KUJU - 216 - DHN - 2018

THIS SIP SUPERCEDED PREVIOUS SIP NO. ECR/SIP/DHN/494/2015 ALT-II
AUHTORITY OF WORK:- P.B. ITEM NO.- 9 OF 2016-17

पूर्व मध्य रेलवे धनबाद मंडल EAST CENTRAL RAILWAY DHANBAD DIVISION	APPROVED BY	COUNTER SIGNED BY		CHECKED BY								DRAWN BY	C.R.S. SANCTION NO.	SCALE			
	11/7/18 CSTE / PLG / HJP FOR CSTE / ECR / HJP	(S.KUMAR) CTM/ECR/HJP FOR COM / ECR / HJP	2/07/2018 (RAJESH KUMAR) CSTE /C/S/ MHX	27/6/18 (ANDHAR RAJ) SR. DOM/DHN		27/6/18 (AJIT KUMAR) SR.DSTE/C/DHN	27/06/18 (AMRENDRA SINGH) DY.CSTE/C/DHN	21/06/18. (B.K. SINGH) DY.CSTE/C/S/MHX	27/6/18 (MOHD RAFI AHMAD) DSTE/C/DHN	V.K.S. (V. K. SINGH) ASTE/C/MHX	(O.P. GOND) SSE/DRG/MHX	(RANJEET KUMAR) JE/DRG/MHX	DATE :- COMPLETED ON	LONGITUDINAL : 1CM = 10M TRANSVERSE : 1CM = 5 M BASED ON - CE. DRG. NO.- Y-81-2017 (ALT-I)	CENTRAL PANEL SIGNAL INTERLOCKING PLAN MACLS, CLASS-B,STD-II(R)	KUJJU (KUJU) कुज्जू	SIGNALLING PLAN NO. ECR / SIP/ DHN/494/2018
	CHECKED BY 11.7.18 DY. CSTE/HJP	11.7.18 JE/DRG

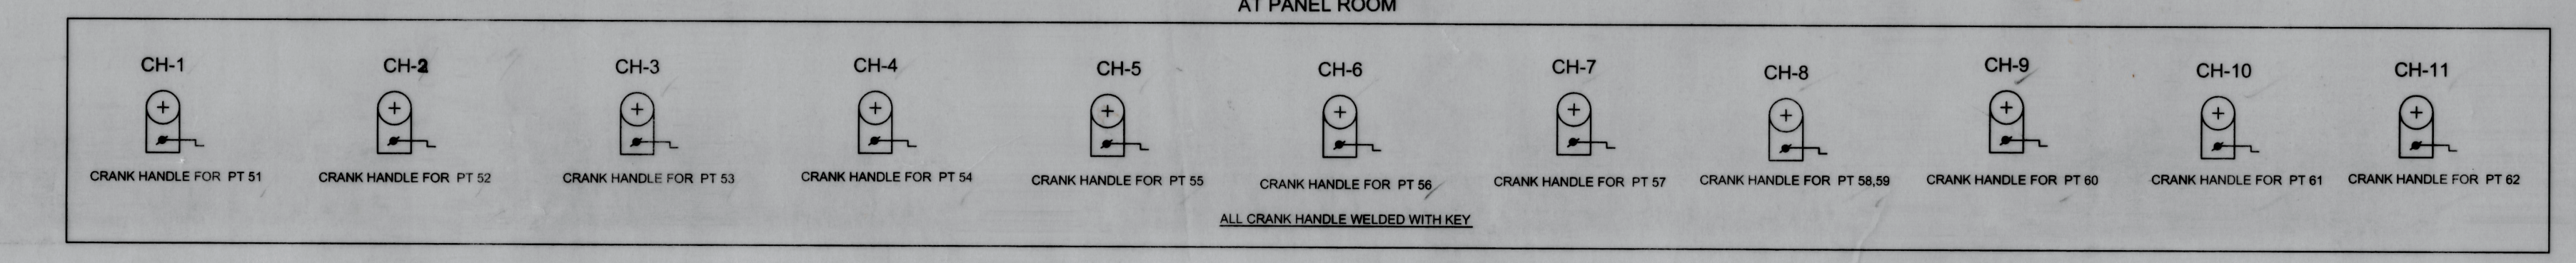
1. ABSOLUTE BLOCK SYSTEM OF WORKING WITH CHARHI & ARIGADA STN.
2. ~~SINGLE LINE TLBI WORKING WITH CHARHI & ARIGADA STN. SITUATED AT PANEL ROOM.~~
3. ALL ANGLE OF CROSSINGS ARE 1 IN12 EXCEPT AS MENTIONED.

4. CONTROL TELEPHONE PROVIDED AT PANEL ROOM.
5. AXLE COUNTER PROVIDED FOR LAST VEHICLE VERIFICATION & INTERLOCKED WITH BLOCK INSTRUMENT OF CHARHI & ~~ARIGADA~~ STN.

6. LED SIGNAL PROVIDED FOR ALL MACL SIGNALS.
7. ~~TRACK CIRCUIT 1T,2T & 13T, 14T ARE STAGGERED BY 1.82M~~
8. THIS SIP HAS BEEN MADE IN CONNECTION WITH NEW BG LINE BETWEEN KODERMA TO RANCHI VIA HAZARIBAG & BARKAKANA

9. 60 SEC. TIME DELAY PROVIDED FOR ALL CALLING-ON RECEPTION SIGNAL.
10. THIS SIP IS SUITABLE TO SUIT 25 KV AC RE TRACTION AREA.
11. UFSBI BLOCK PANEL WITH HASSDAC SINGLE LINE TYPE WORKING WITH KUJU-ARIGADA SITUATED AT SM'S ROOM.

12. UFSBI BLOCK PANEL WITH HASSDAC SINGLE LINE TYPE WORKING WITH KUJJU-CHARHI SITUATED AT SM'S ROOM.
